**RE: KEYYASK GENERATION PROJECT – ALTERATION REQUEST, SOUTH ACCESS ROAD  
ENVIRONMENT ACT LICENCE NO. 3107, CLIENT FILE 5550.00**

**Keeyask Generation Project – South Access Road**  
**Description of Proposed Modifications and Potential Environmental Effects**

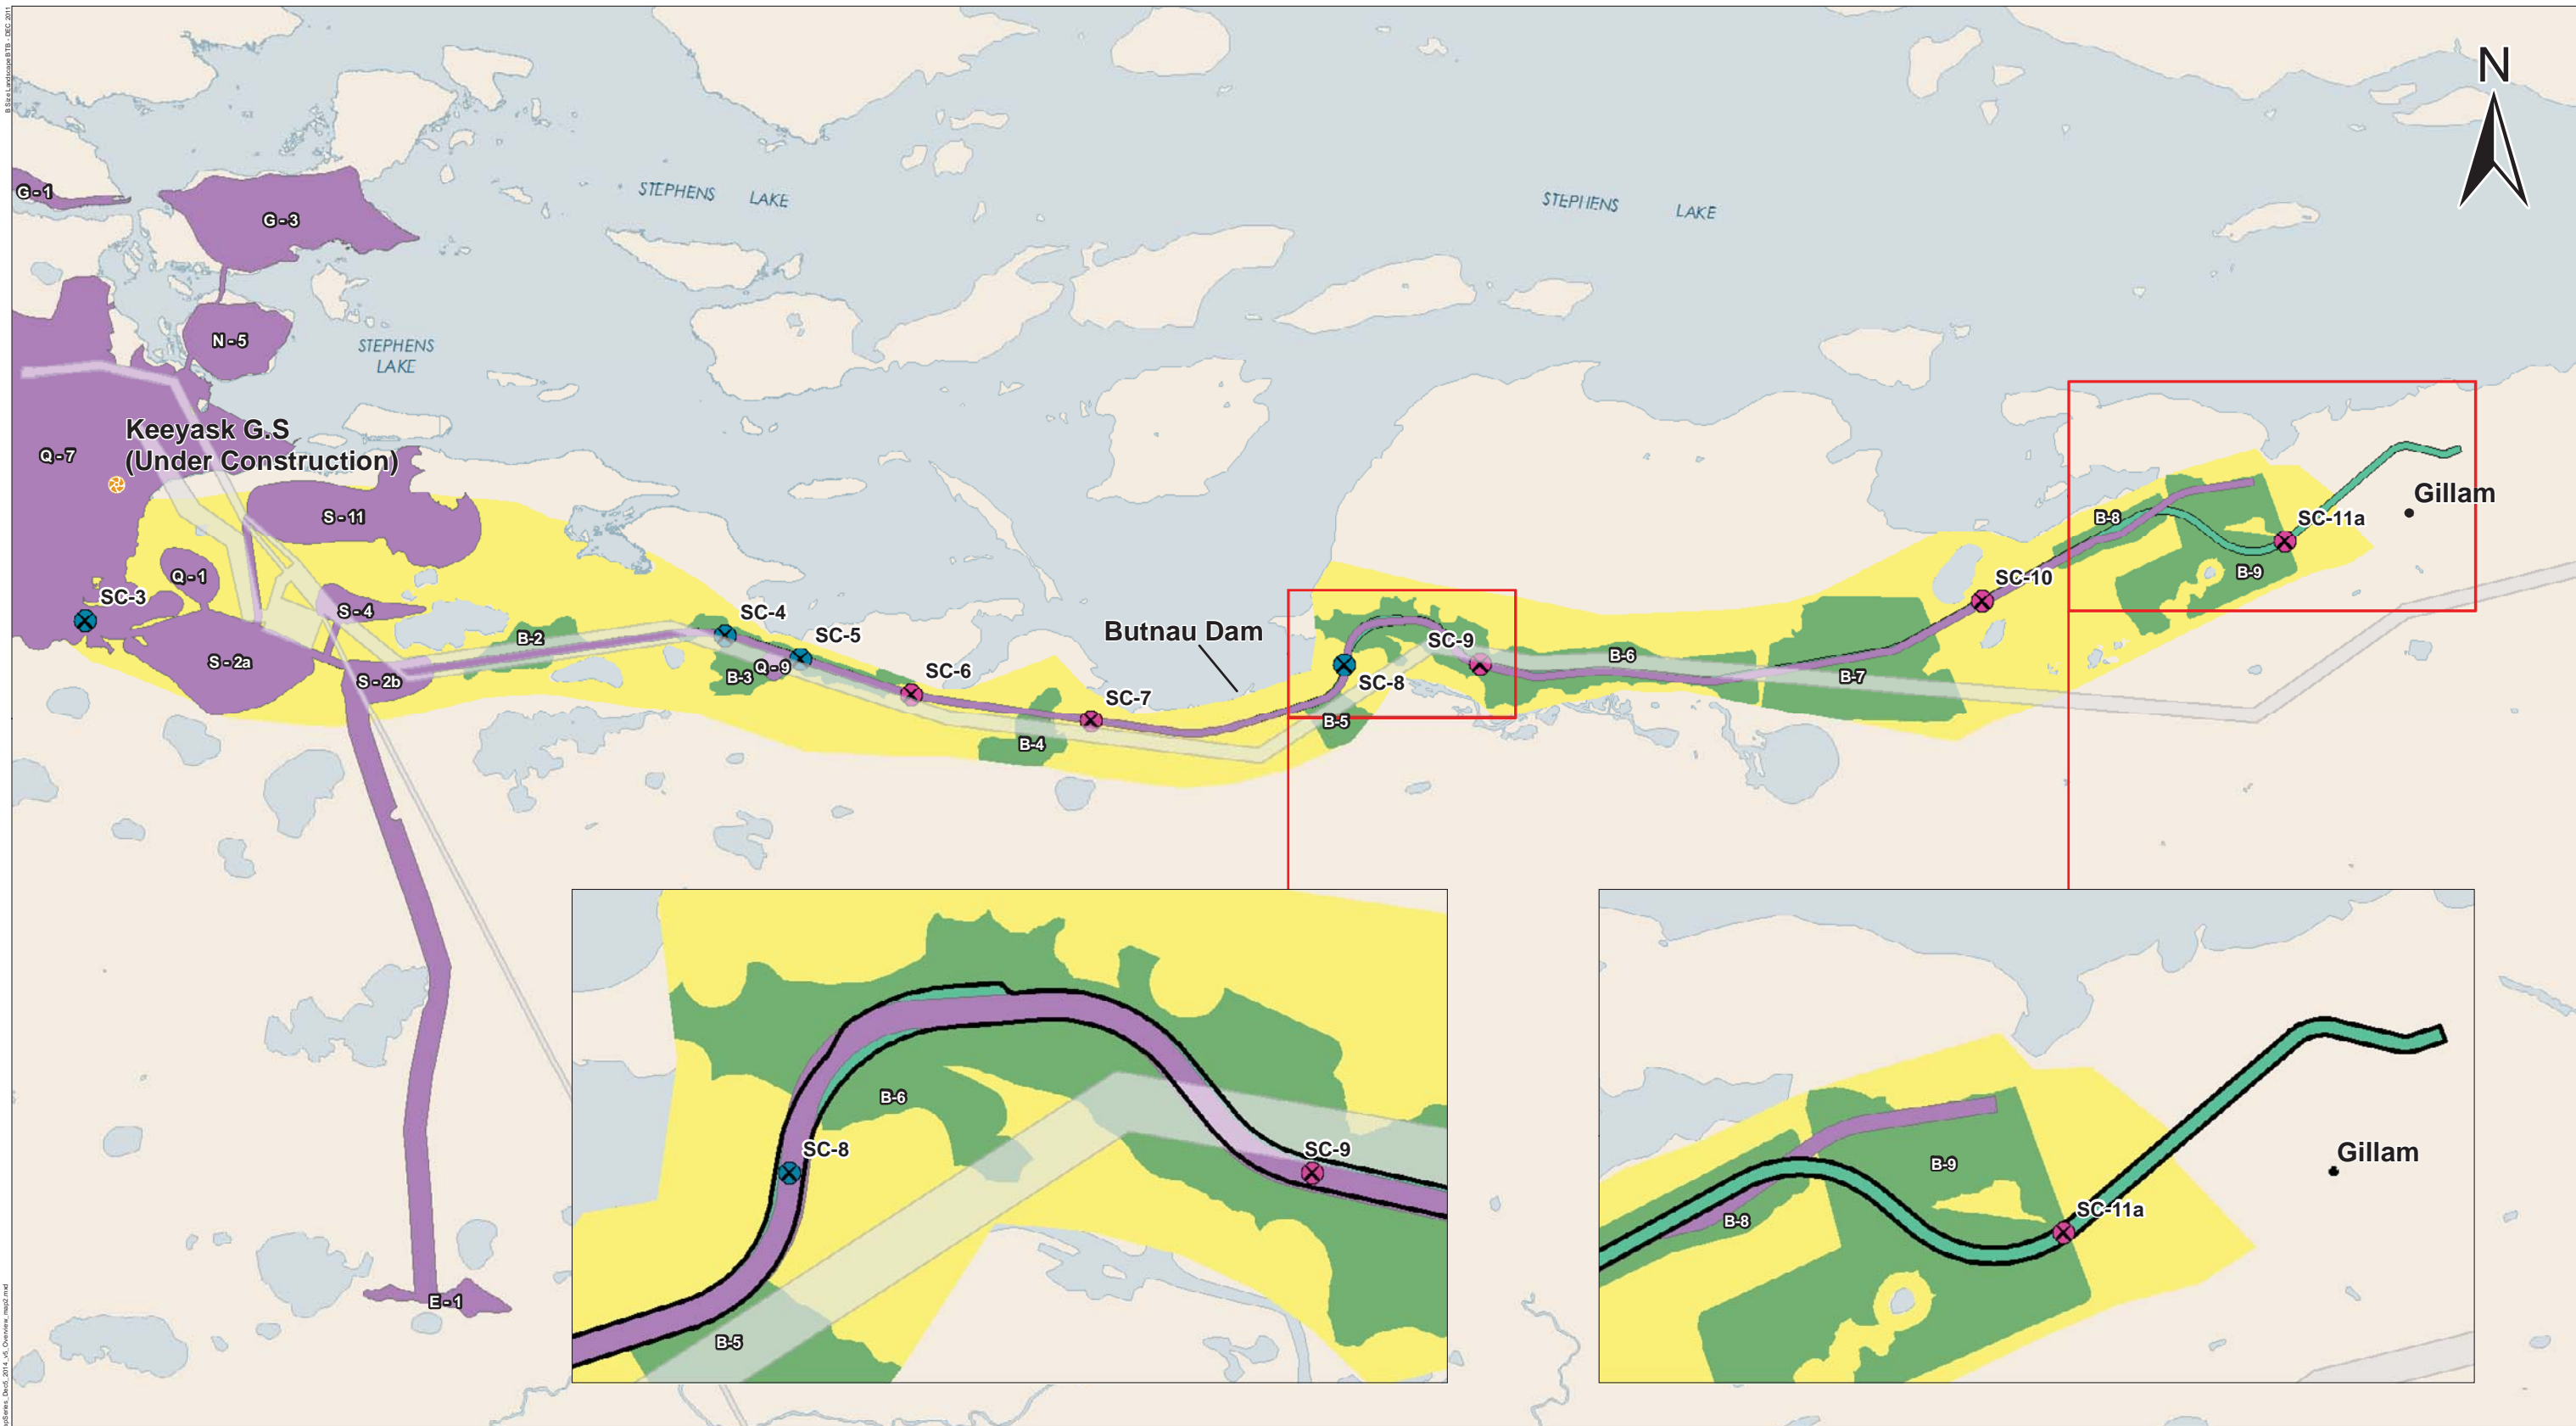
The Project EIS identified the need for additional material source areas. It is proposed that the Project footprint be expanded by approximately 4500 hectares to include a corridor along the entire length of the SAR from which borrow material can be sourced (identified as the South Access Road Corridor on the Proposed Alteration map). Within the corridor, there is approximately 1190 hectares identified as material source areas; these areas have the highest potential for viable material sources and avoid most environmentally sensitive sites (refer to the Terrestrial Assessment Section). It is likely that only a portion of the material source areas will be required for construction of the SAR. The entire corridor is being requested to be added to the footprint to reduce the risk of insufficient material being available within the licenced footprint.

A small widening of the right-of-way (ROW) is required at the proposed security gate location for the SAR – an area at the junction of the western portion of the SAR and the current Butnau Road (see Proposed Alteration map). This widening is required so that the Partnership can meet Provincial Road design standards for intersections. This widening of the ROW would be within the proposed new road corridor identified above for material source areas.

A re-alignment along the eastern half of the road is proposed to enhance access into Gillam and to accommodate future planning opportunities within the Town. The proposed re-alignments are shown on the Proposed Alteration map. There is a route shift in the vicinity of stream crossing 8 (SC-8) and near the connection to the Town of Gillam, as well as a slight shift generally north of the original alignment for the rest of the eastern half of the road. The final alignment of the road identified additional stream crossings that were not assessed in the Project EIS.

The heritage assessment of the SAR re-alignment identified crossing SC-11a (see Proposed Alteration map) as an area that has potential for the presence of undiscovered heritage resources. SC-11a is a crossing of an unnamed tributary that flows into the Kettle River. The crossing will be cleared right to the edge of the water with no anticipated ground disturbance. The Keeyask Generation Project Construction Heritage Resources Protection Plan will be adhered to if any heritage resources are discovered during the course of clearing or other construction activities related to the Project. The Project archaeologist will advise and provide field support should any heritage concerns arise during construction.
